ADDENDUM NO. 4

**Armstrong Field
815 Jefferson Street
Three Rivers, MI 49093**

ARMSTRONG FIELD

ADDENDUM 004

STADIUM SITE PLAN

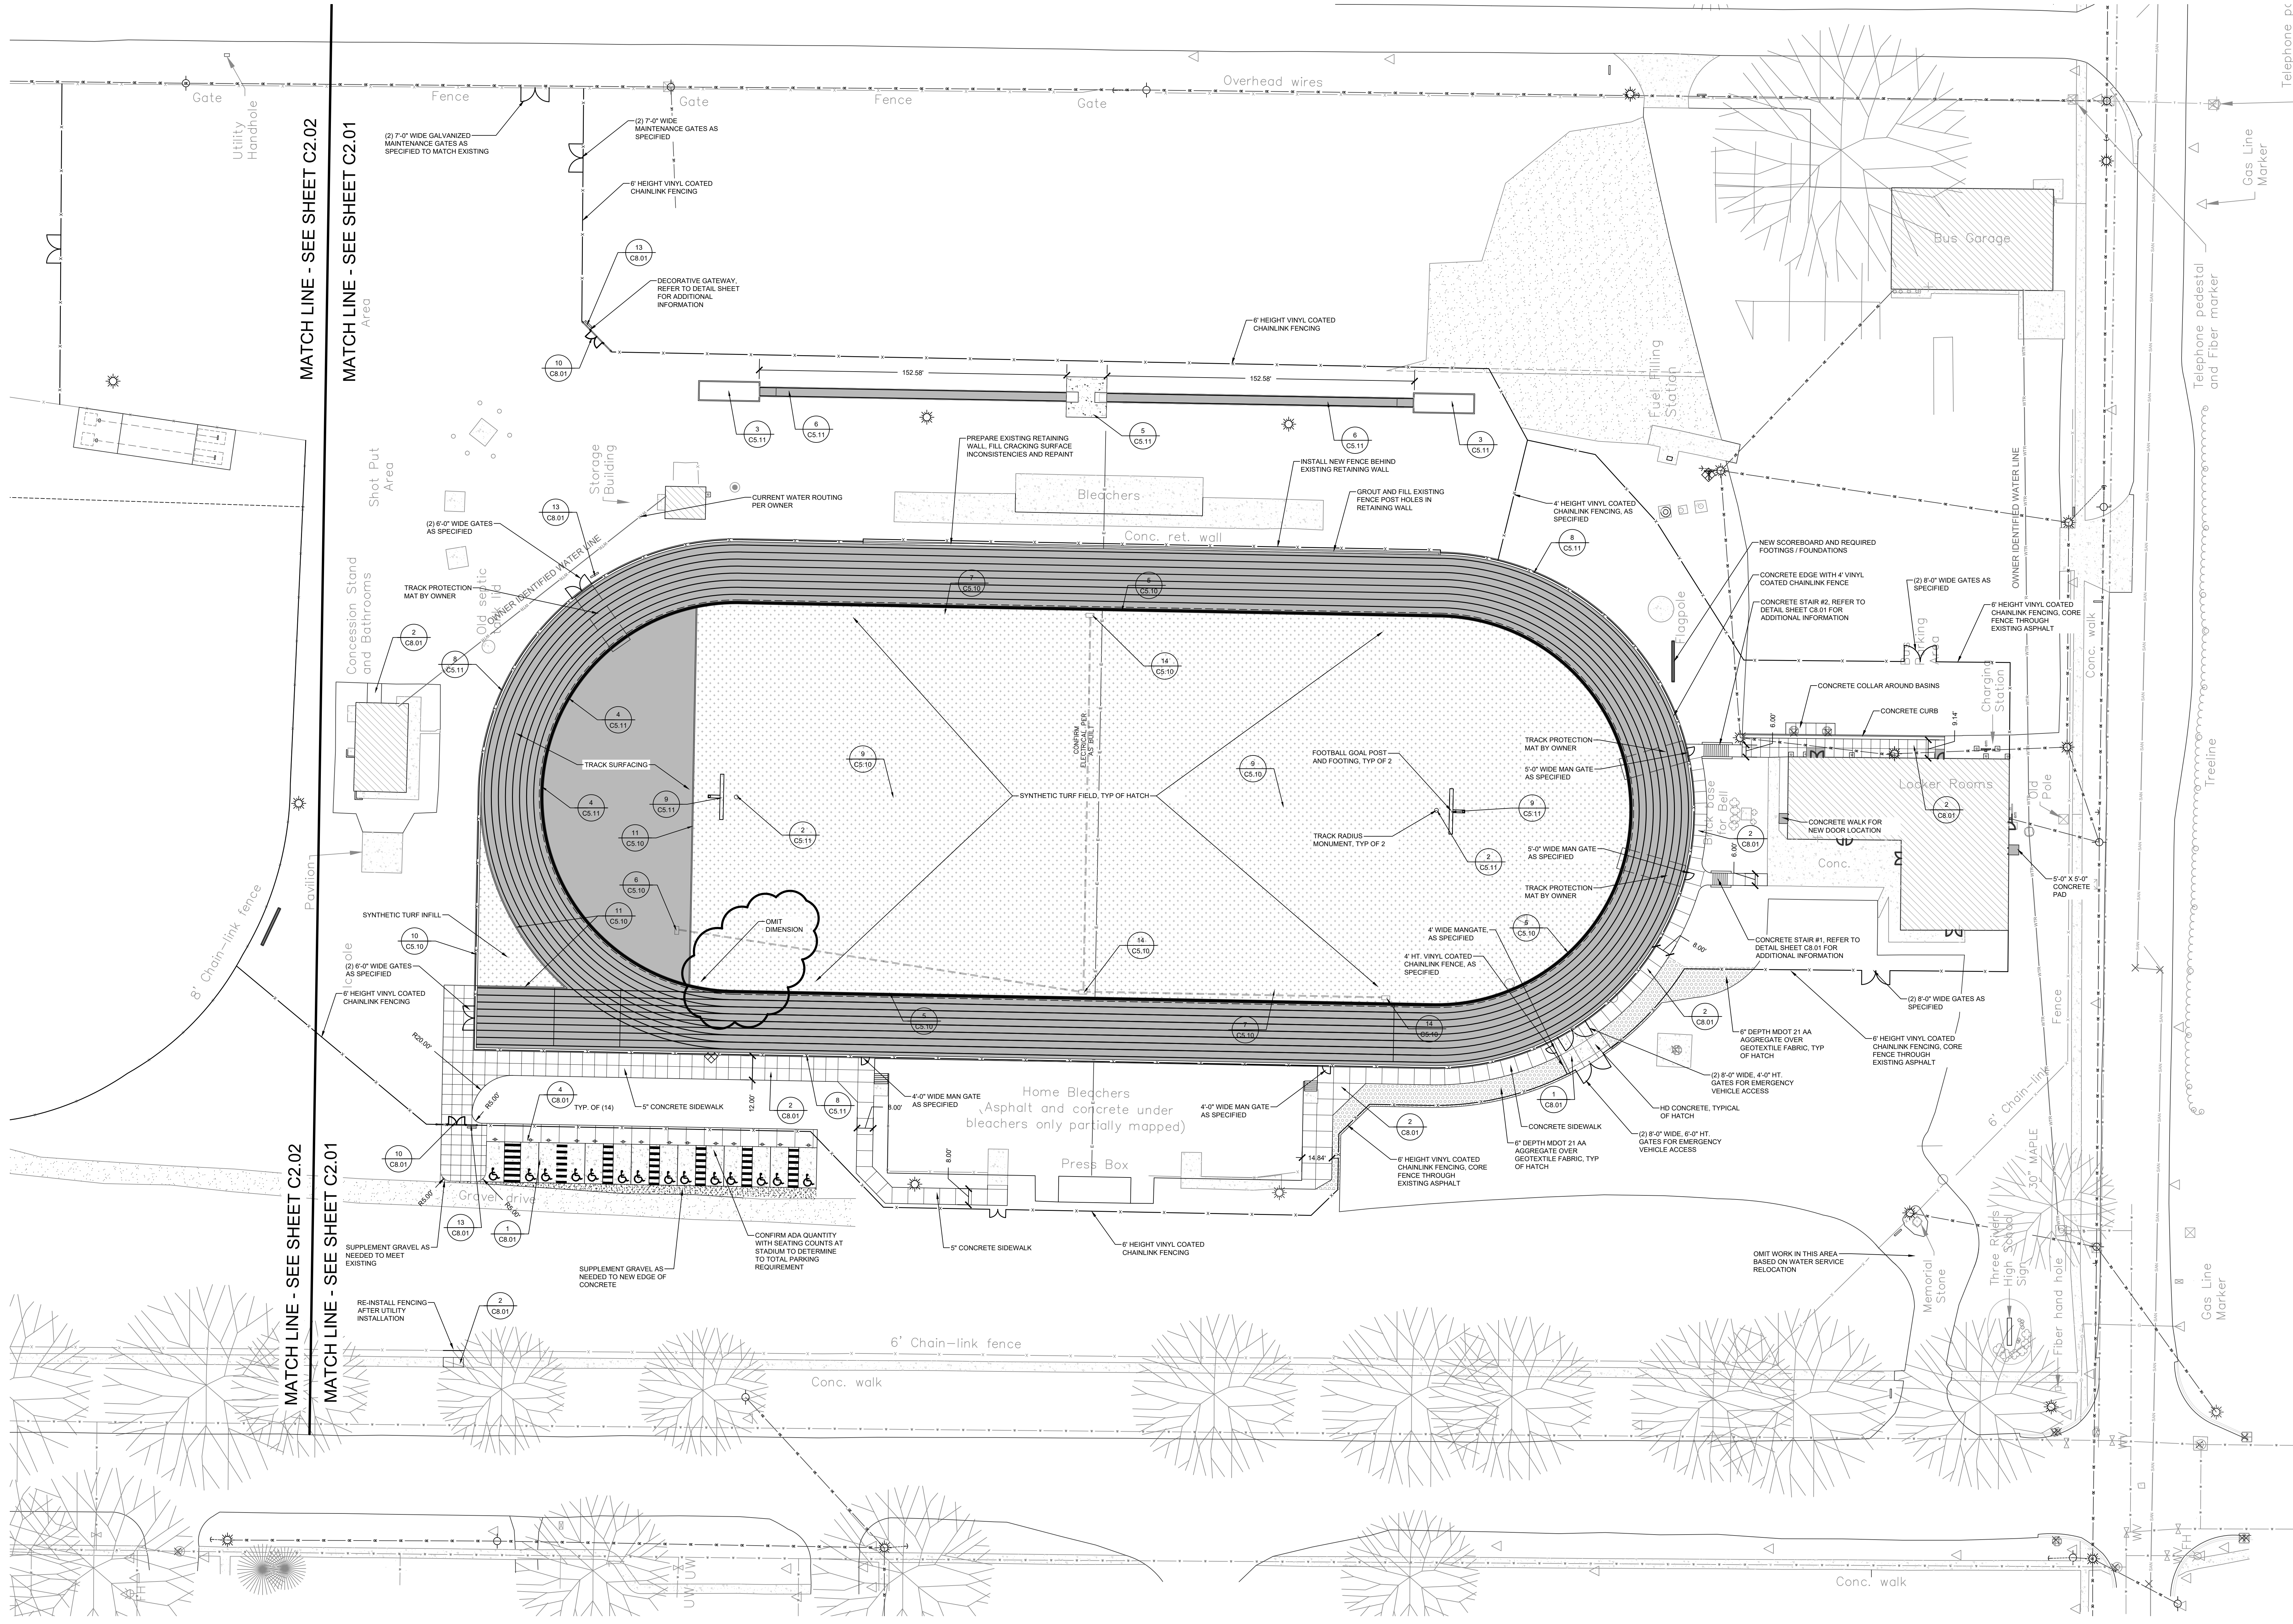
11. The concrete maintenance strip (Sheet C2.01, detail 8/C5.11 Concrete Turn Down at Edge of Track) is to stop at each end of the existing retaining wall and does not continue in front of the wall.

- ITEM NO. 3 SHEET C2.01 – STADIUM SITE PLAN (REISSUED)
Refer to plan for omitted dimension.
- ITEM NO. 4 SHEET C2.02 – BASEBALL SITE PLAN – ALTERNATE C-1 (REISSUED)

8 CONCRETE TURN DOWN AT EDGE OF TRACK
C5.11 NOT TO SCALE

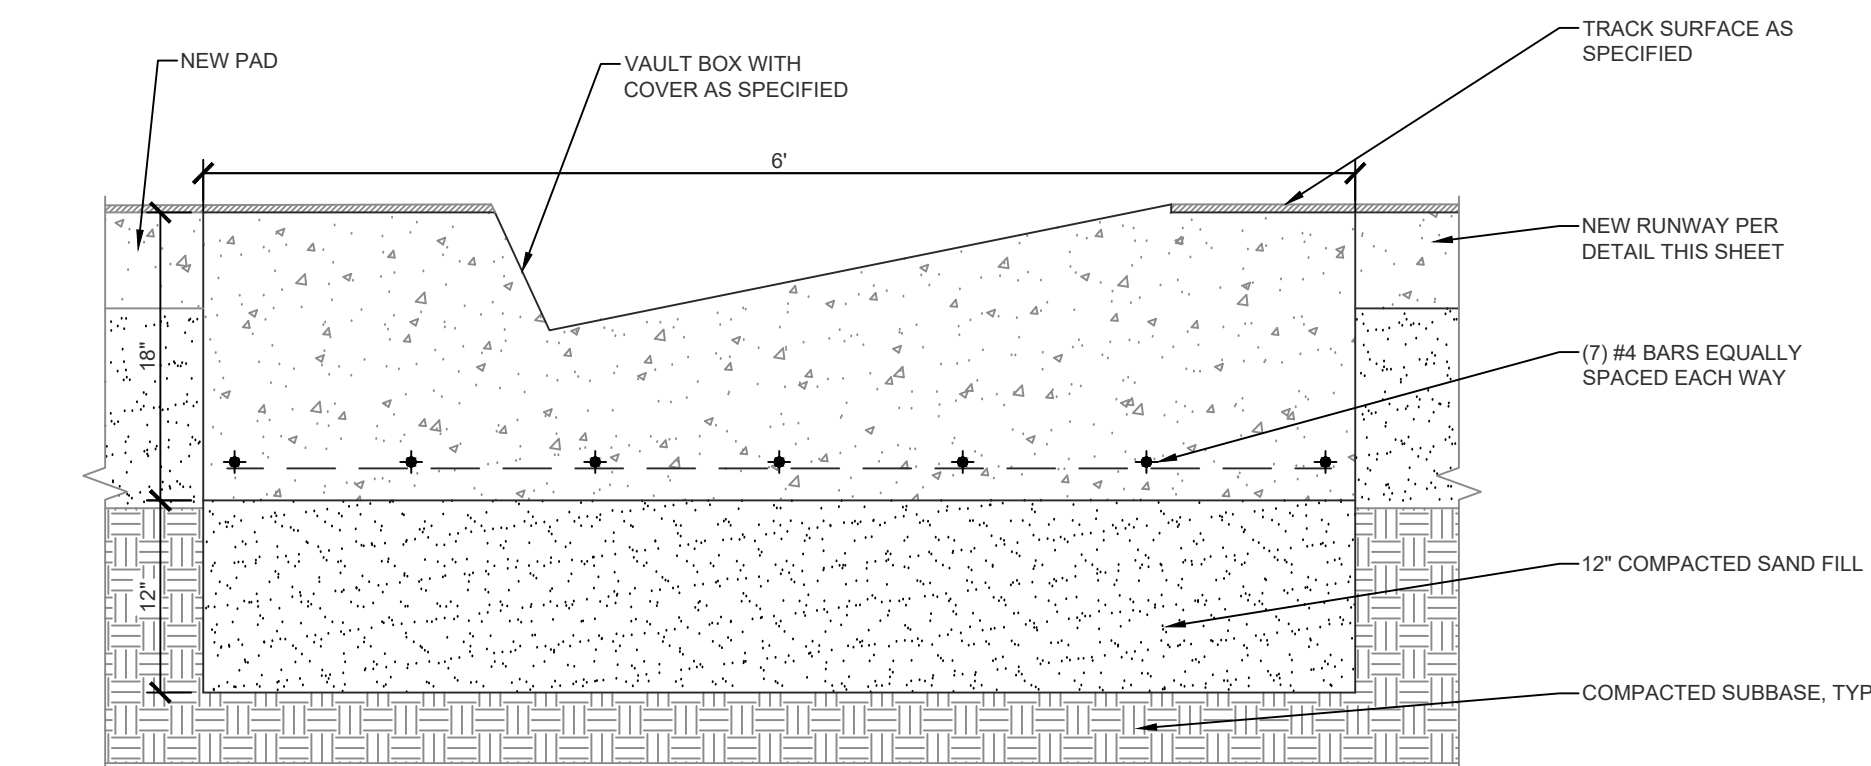
21. The concrete maintenance strip (Sheet C2.01, detail 8/C5.11 Concrete Turn Down at Edge of Track) is to stop at each end of the existing retaining wall and does not continue in front of the wall.

OPTIONAL SPREAD FOUNDATION

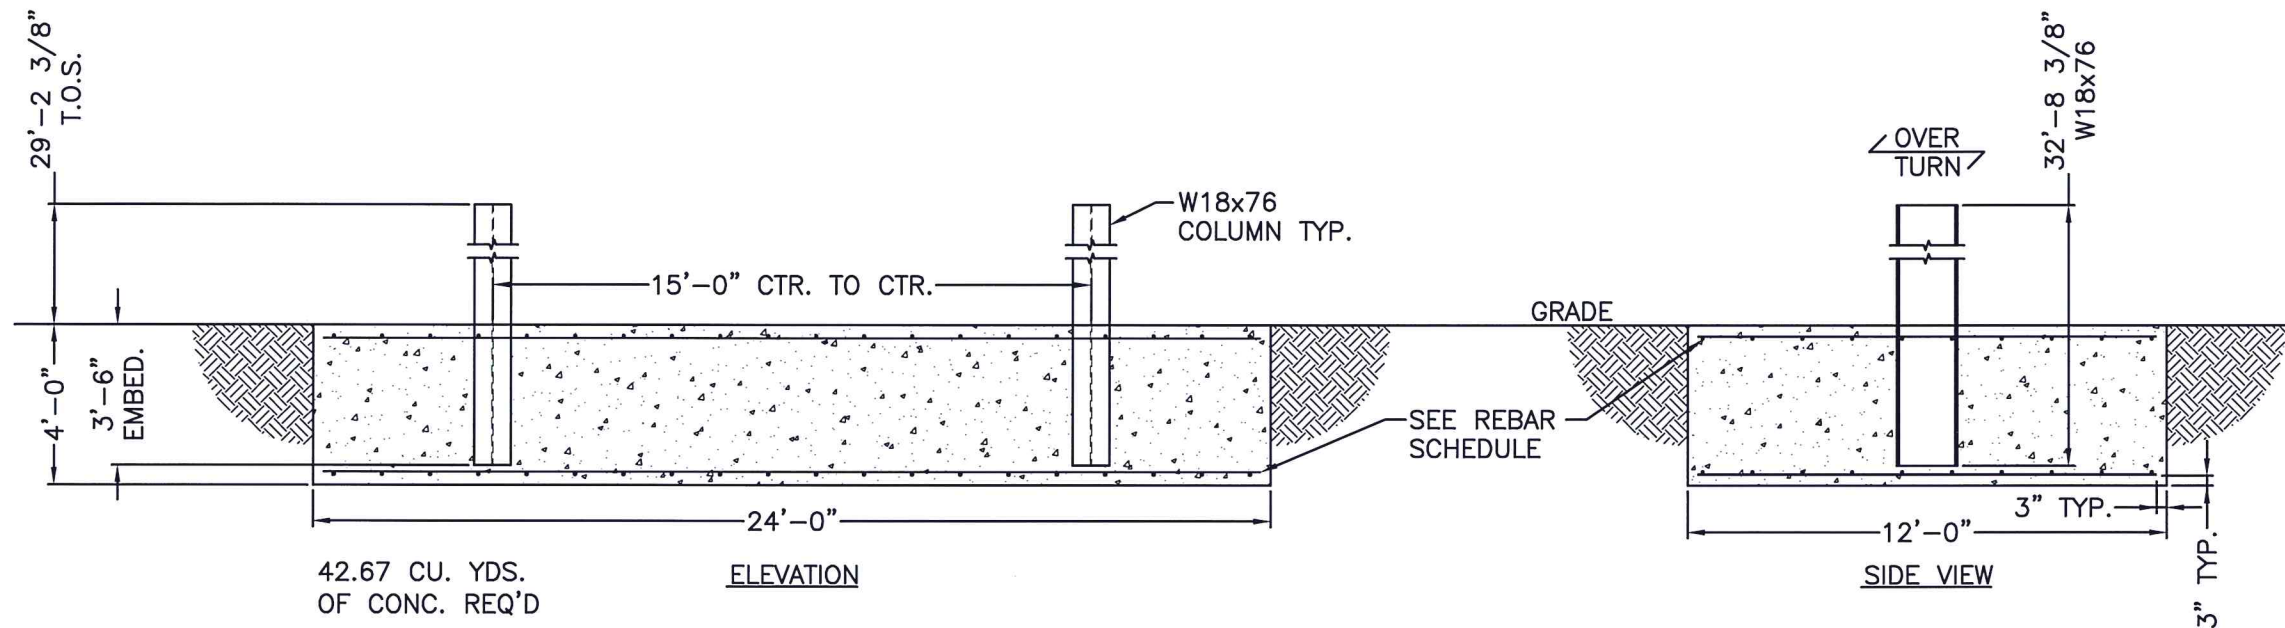
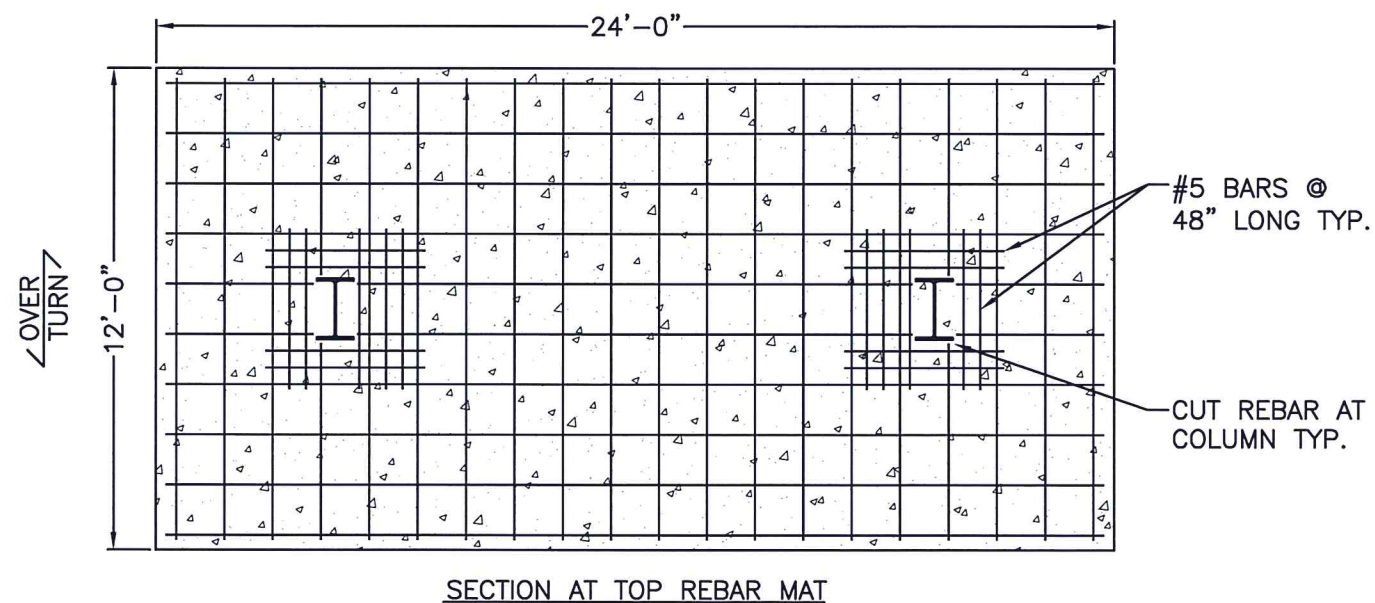
ITEM NO. 11 SHEET B1191803R-3 – DAKTRONICS SCOREBOARD STRUCTURAL DRAWING
(NEW)

Sheet added to include optional spread footing for football field scoreboard structure.

Project Number: 23-0541R2		Drawing Number: B1191804R	
SHT. 1	OF 1	DATE: 11/29/23	BY: TR

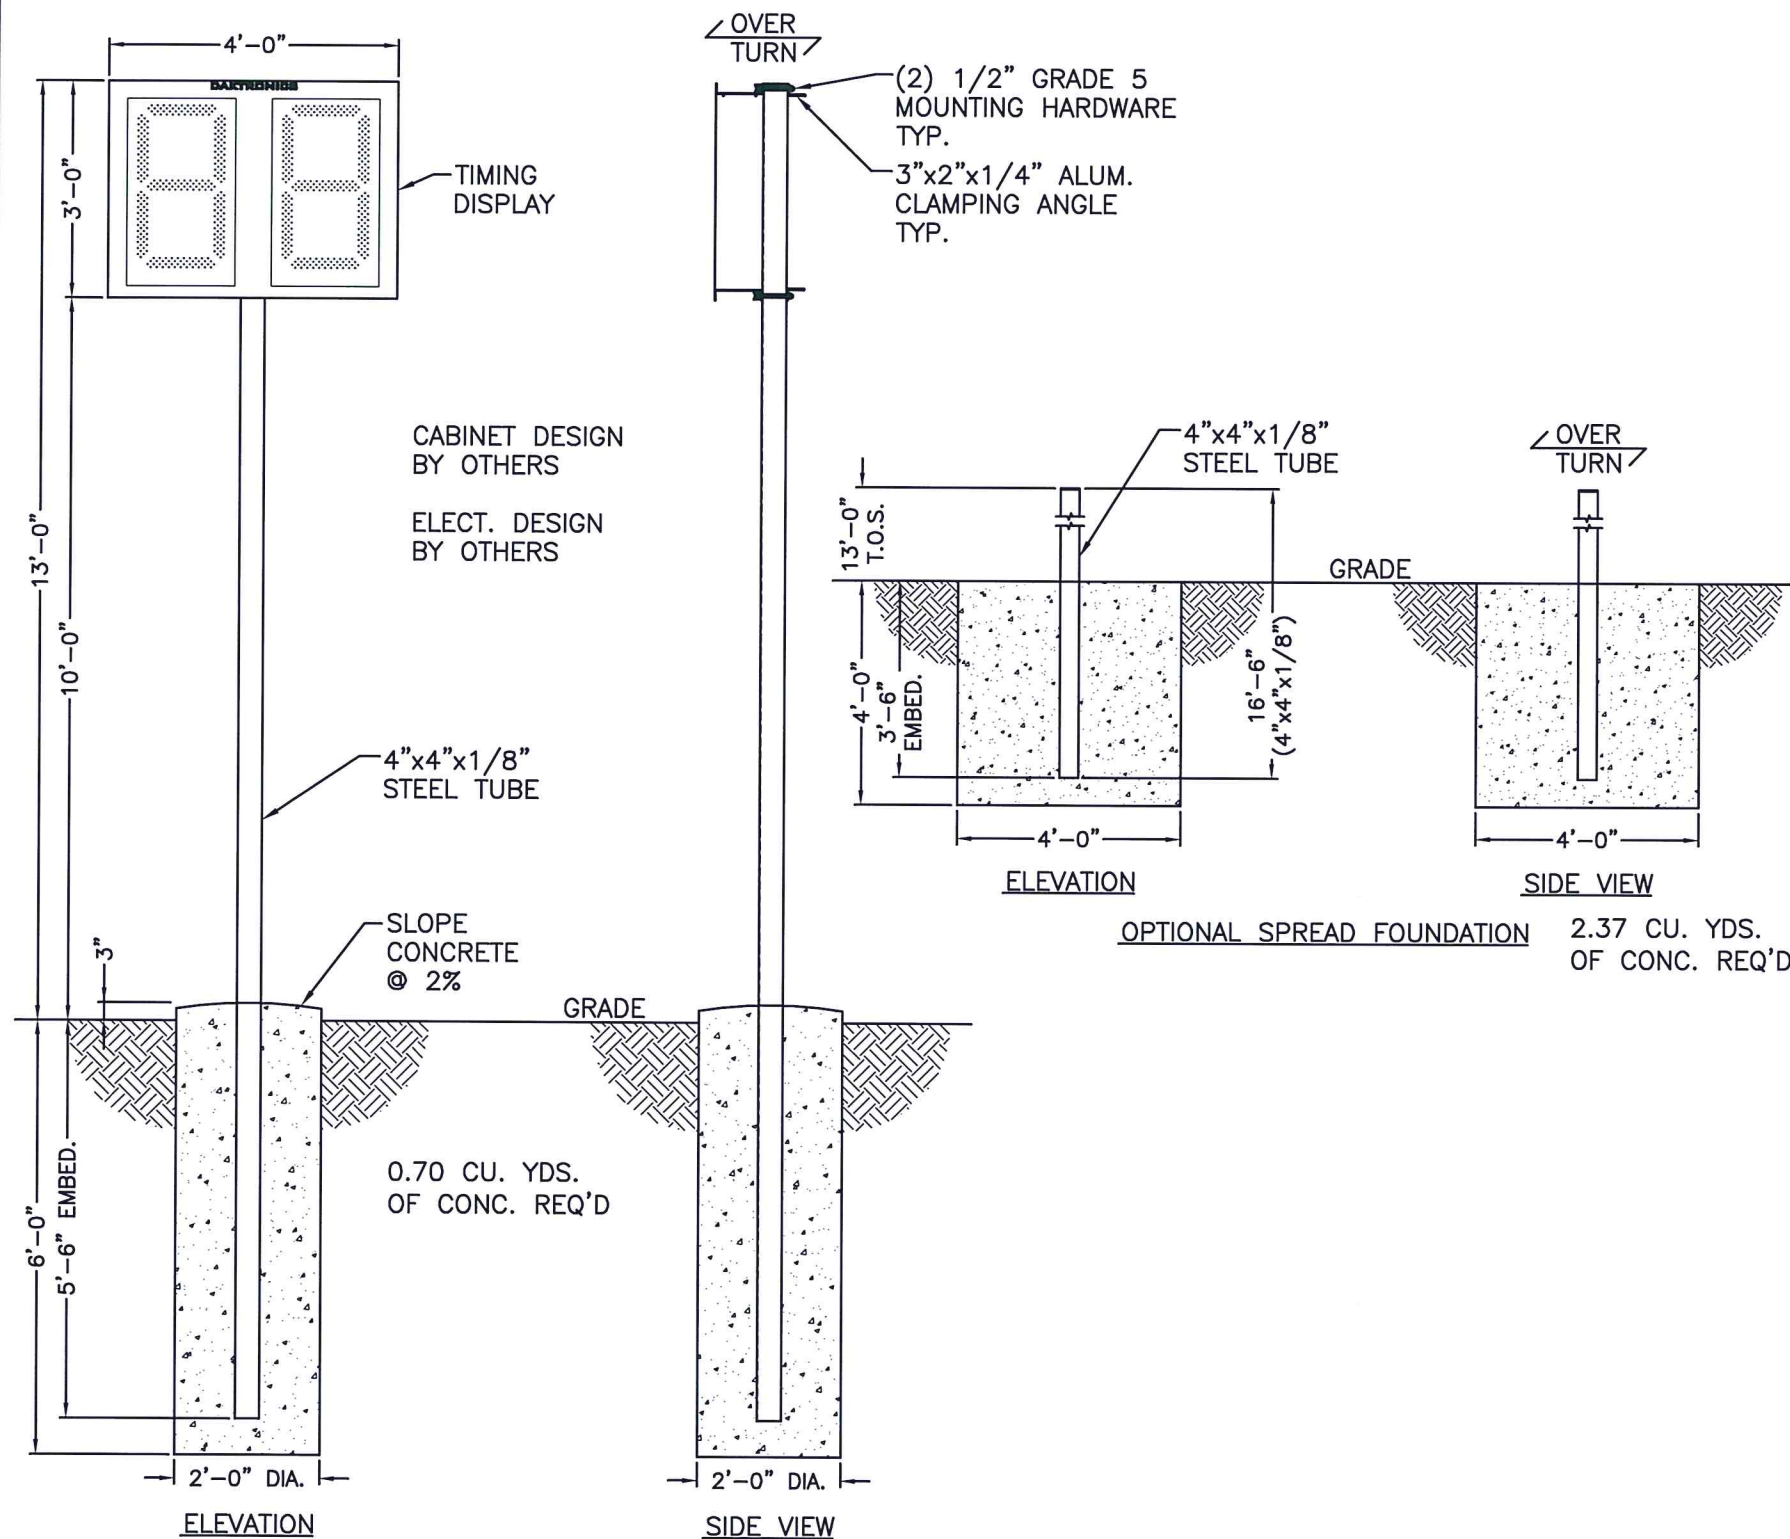
12. Refer to details on Daktronic Sheet B1191804R foundation and post details for the 25 second timeclock. These details replace foundation and post details of Detail 6/C5.10.

10. Refer to details on Daktronic Sheet B1191804R foundation and post details for the 25 second timeclock. These details replace foundation and post details of Detail 6/C5.10.

17. Refer to details on Daktronic Sheet B1191804R foundation and post details for the 25 second timeclock. These details replace foundation and post details of Detail 6/C5.10.
